Galestina Canyon

SUNDRY NOTICES AND REPORTS ON WELLS

Request approval for a change of plans as follows:

WELLBORE SCHEMATIC

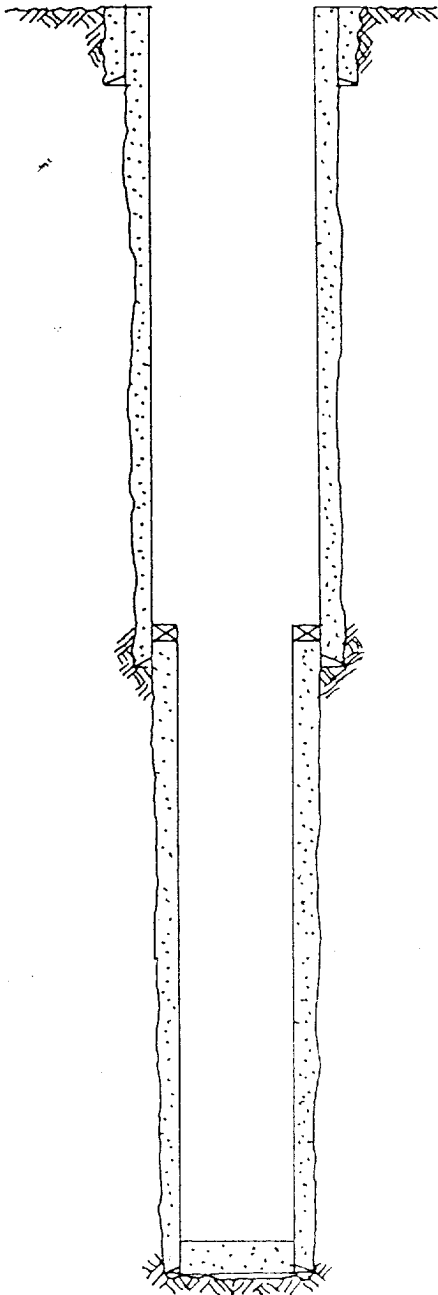
Propose to drill a 12-1/4" hole to 40' KB. Set one joint 9-5/8" 36 lb/ft J-55 conductor pipe with 15 sacks (18 cu.ft.) Class 'B' neat, 2% CaCl₂. Drill 8-3/4" hole to approximately 1850' KB. Set 7" 20 lb or 23 lb/ft J-55 casing @ 1850' KB with 200 sx (328 cu.ft.). Estimated top of cement at surface. Wait on cement 10 hours. Pressure test casing to 1200 PSI. Drill 6-1/4" hole to TD @ 2700' KB. If deemed advisable, will run a drill stem test. Run open hole logs. If well appears productive, will set 4-1/2" J-55 10.5 lb/ft liner from 1650' to TD @ 2700' KB w/ 100 sx (122 cu.ft.). TOC @ liner top. Will perforate and stimulate as necessary to test well. Additional drilling program details attached. No other changes are requested at this time.
